REPORT TO THE PLANNING COMMISSION

TITLE: Oasis Plaza - Adopt a Minute Motion approving a Development Permit, Design Review Permit, and Mitigated Negative Declaration to construct two (2) commercial buildings totaling 7,992 square feet within the C-G (General Commercial) Zoning District, located on the southeast corner of Third Street and Palm Drive in the City of Desert Hot Springs (Assessor's Parcel Numbers: 639-281-006, 007, 008, 009 & 010).

CASE NO: Development Permit No. 04-13, Design Review No. 04-13 & Mitigated Negative Declaration (EA 01-13)

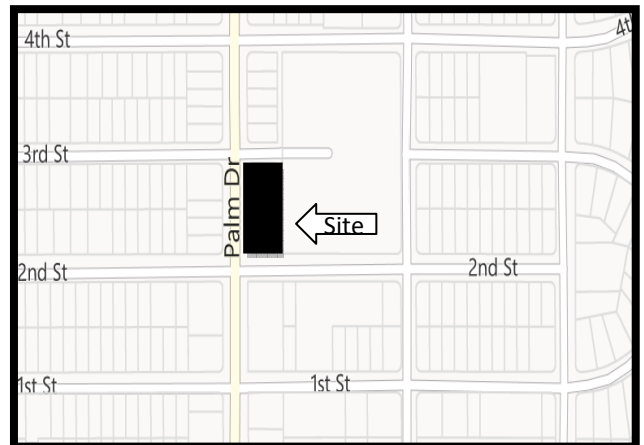
- f. Provide a detail of how the climbing shrub will be attached to the building.

The Vine Detail has been provided on Sheet P-2 with the wiring against the wall. However, it was also requested there be a metal framework provided that leave a small space against the wall. Staff has provided that detail to the right and will ensure it is part of the final plans.
